AERONAUTICAL CHARTING FORUM
Instrument Procedures Group
April 28, 2009
HISTORY RECORD

FAA Control # 09-01-282

Subject: Glide Slope Intercept Altitudes on ILS Parallel Approaches

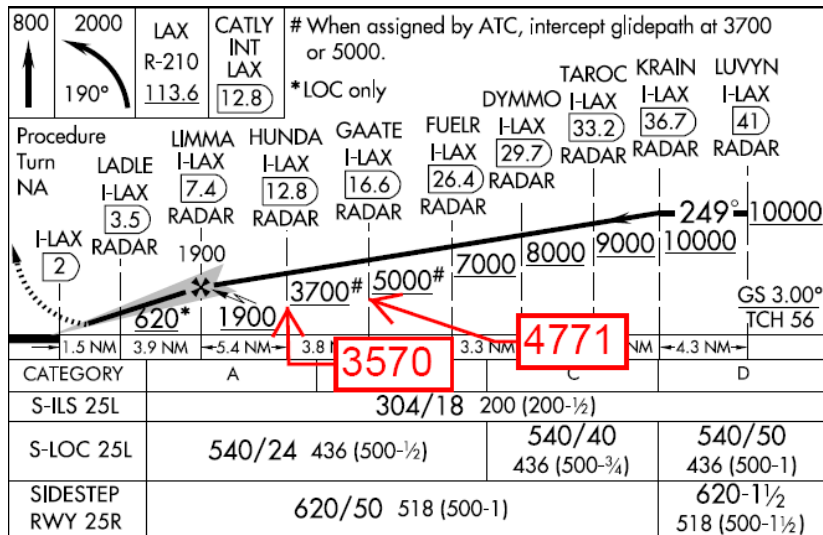
The note advises the pilot to intercept the glidepath, but fails to address the applicability of the published step-down fix minimum altitudes that are encountered during the subsequent descent. Interception of the glidepath (ILS glide slope) does not necessarily ensure that subsequent step-down fixes will be crossed at or above the published minimum crossing altitude, which is an expectation that is stated in AIM 5-4-5 (b)(1). An example of this situation may be seen on the ILS 25L at Los Angeles, CA (LAX) which is depicted below. The estimated ILS glide slope MSL crossing altitudes depicted by red boxes:

NBAA is concerned that lacking sufficient guidance on the instrument procedure chart and in the AIM, the pilot may cease tracking of the glidepath if he/she perceives that the aircraft will descend below the published step-down fix minimum altitude. This may result in not achieving the required altitude separation expected by ATC during simultaneous ILS approach operations. NBAA is also concerned about a pilot's understanding of the implications of an ATC assignment to intercept glidepath at an altitude other than the glide slope interception altitude as noted on the IAP and how this relates to the final approach fix location. The "lighting bolt" symbol depicted on US Government charts provides two critical pieces of information to the pilot.

Recommendations: To reduce the chart clutter and to clearly state the applicability of published step-down fix altitudes encountered after the glidepath has been intercepted as instructed by ATC, NBAA suggests the following:

- Revise the note to clearly state the applicability of subsequent step-down fix altitudes when the glidepath is intercepted prior to the published glide slope intercept altitudes as follows:

“When assigned by ATC, intercept and track glidepath. Disregard subsequent step-down altitudes.”

ILS or LOC RWY 16L SEATTLE-TACOMA INTL (SEA)

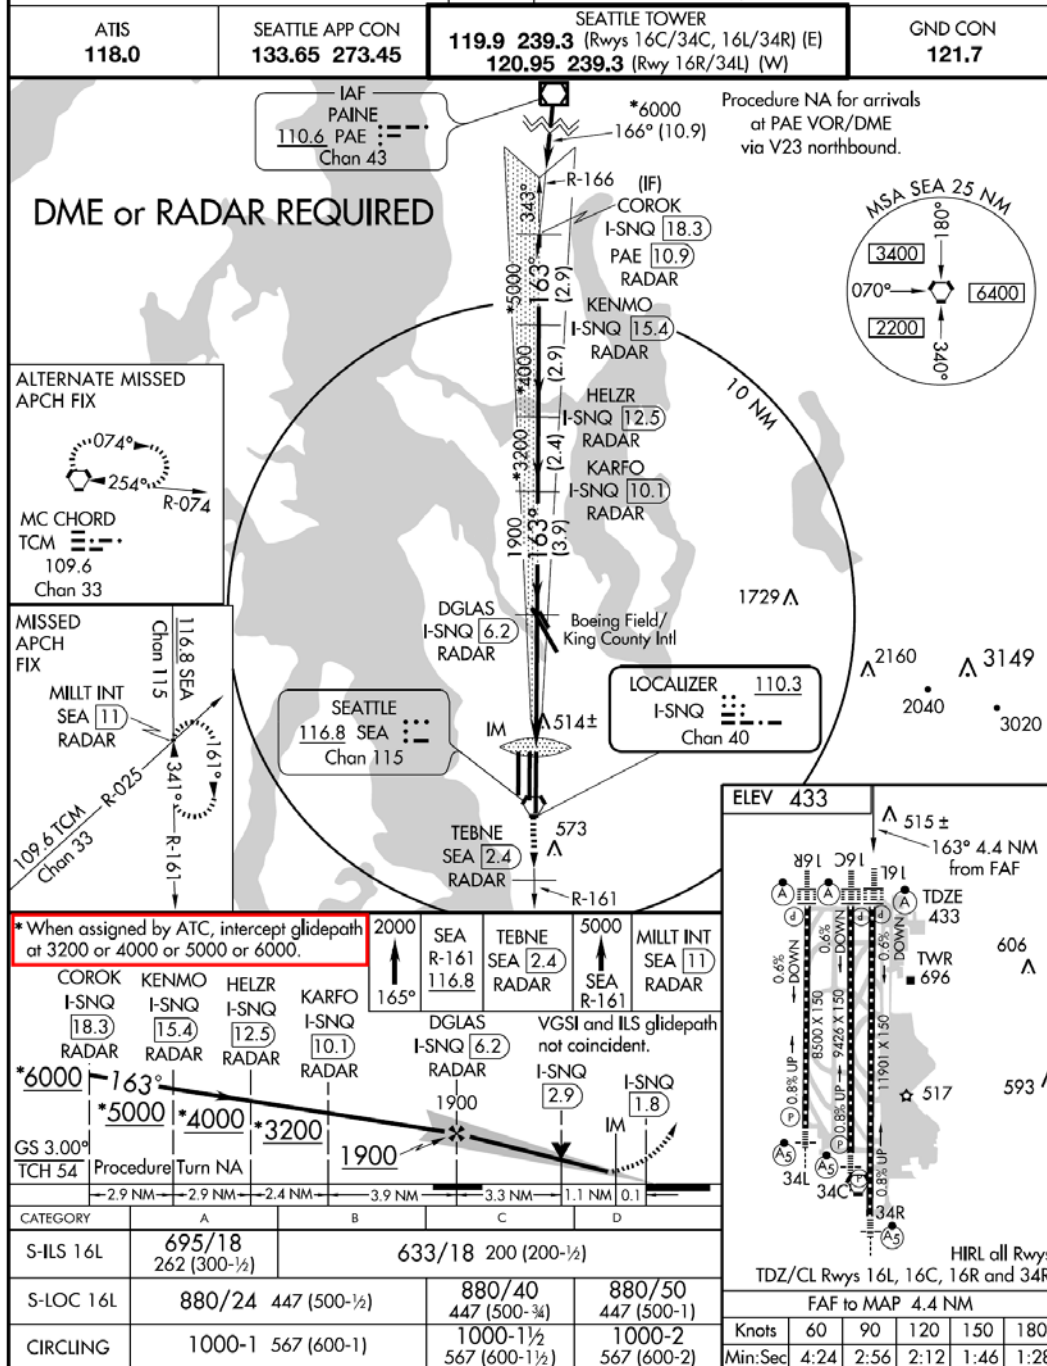
Finally, NBAA is concerned about the need to publish each altitude where ATC may authorize a pilot to intercept the glidepath. We feel that this needlessly clutters the chart profile view. We question whether it is necessary to identify each step-down crossing altitude where ATC may assign a clearance to intercept and track the glidepath. Please see attached examples for LAX ILS 25L and SEA ILS 16L approaches

ILS or LOC RWY 25L
LOS ANGELES INTL (LAX)

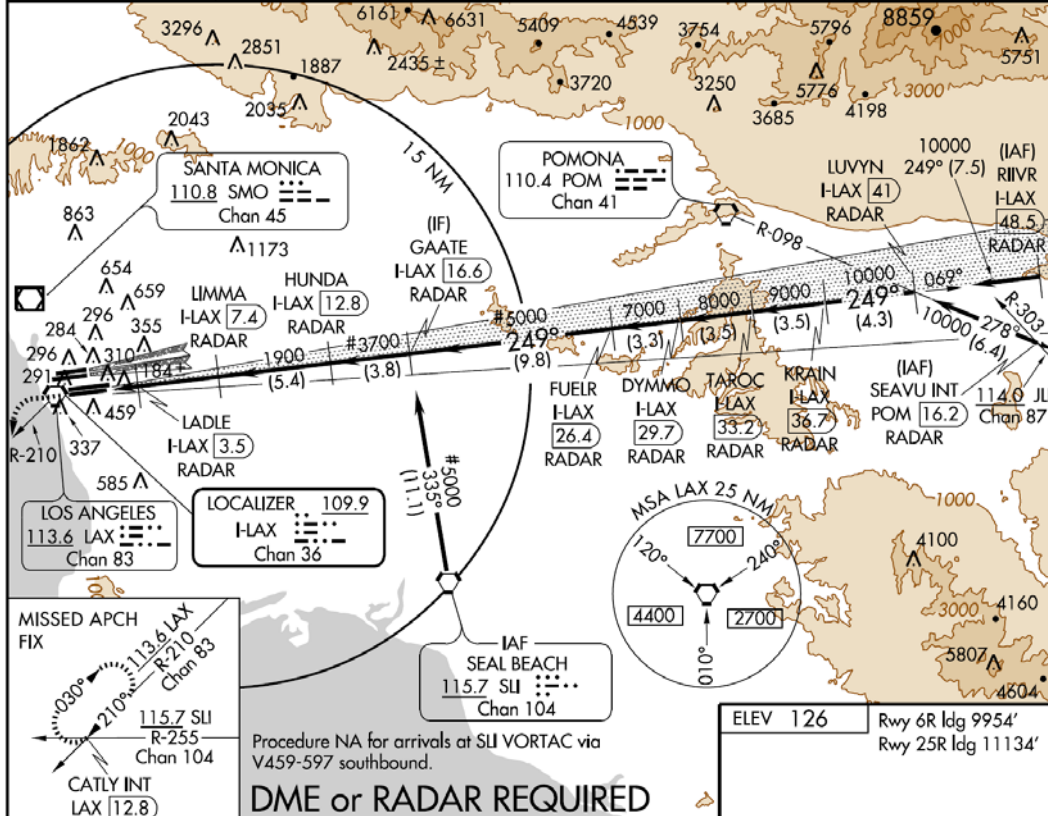
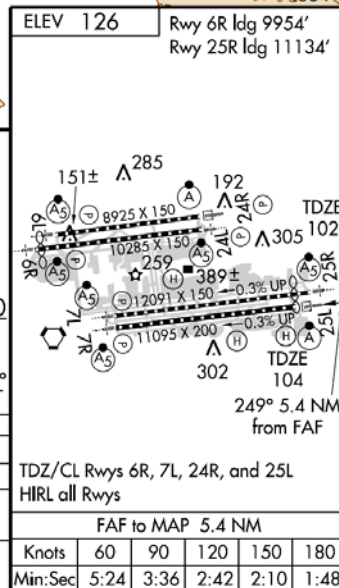
800 2000
190°
LAX R-210 113.6
CATLY INT LAX 12.8
When assigned by ATC, intercept glidepath at 3700 or 5000.
*LOC only

MEETING 10-02: Brad Rush, AJV-3B, briefed that the amendments to revise the stepdown fix locations for the LAX ILS RWY 24L/R and 25L/R approaches are scheduled for the May 5 chart cycle. The changes will ensure that aircraft tracking the ILS glide slope are above the intermediate stepdown fix altitudes. As simultaneous parallel approaches are amended at other airports the new formulae will be applied to those procedures. Rich Boll, NBAA, asked whether this means that aircraft, when cleared for ILS approaches with multiple specified GS intercept altitudes, can track the glide slope and disregard intermediate stepdown fix altitudes. Bill Hammett, AFS-420 (ISI) briefed that the AIM change agreed to at the last meeting had been forwarded for publication on March 10, 2011. This change supports Rich's position. Mike Frank, AFS-52, stated that when cleared for an ILS approach, the pilot still must adhere to specified fix crossing altitudes prior to the PFAF. This position was supported by Gary Fiske, AJT-28. Tom Schneider, AFS-420, stated that procedures with a note authorizing multiple glide slope intercept altitudes are applicable only at locations that permit simultaneous parallel operations. Tom added that the requirement for multiple glide slope intercept altitudes may go away if/when an AFS-450 study (currently in progress) to assess the necessity for vertical guidance when conducting simultaneous operations is completed. Larry Wiseman, AOV-310, asked whether it was the ATO's position to disrupt stabilized descents. Mike responded yes, and emphasized that the stepdown altitudes were for ATC separation purposes and even when the fixes/altitudes were temperature corrected, pilots will be expected to comply with stepdown fix altitudes outside the PFAF. Rich stated that if this is true, then the note requirement on the chart is misleading. He stated that nearly all pilots when cleared for the ILS approach at an altitude annotated on the chart "*when assigned by ATC, intercept glidepath at (altitude)*" are going to intercept and track the glidepath from that altitude to the runway. If the ATC intent is that the stepdown profile is always to be followed, the plan view notes need to be eliminated and the procedures noted in issue 09-01-283 be followed for all ILS approaches. Rich recommended the current chart notes be NOTAMed until the issue resolved. Mark Ingram, ALPA, stated that perhaps the term "vertical path" should be used vice glidepath. Tom Loney, CAF, agreed. Bill Hammett re-capped the current proposed AIM changes with the recommendation that the proposed change under this issue be held pending further discussion. The group agreed and also recommended that an ad hoc group needs to be formed to determine exactly what notation is required on approach charts that support simultaneous operations. Tom Schneider accepted the IOU to check the status of the aforementioned AFS-450 study and recommended no group be formed until the results were in. Mike Frank, AFS-52, stated that temperature correcting all intermediate stepdown altitudes on simultaneous approaches will provide the most effective solution and asked Brad whether this could be given priority. Brad responded that priorities are set through the RAPT and NAPT. Brad also agreed to provide Rich a listing of all simultaneous approaches, which Rich will use to initiate RAPT action. Four IOUs were assigned: 1) AFS-410 to hold the AIM change recommended under
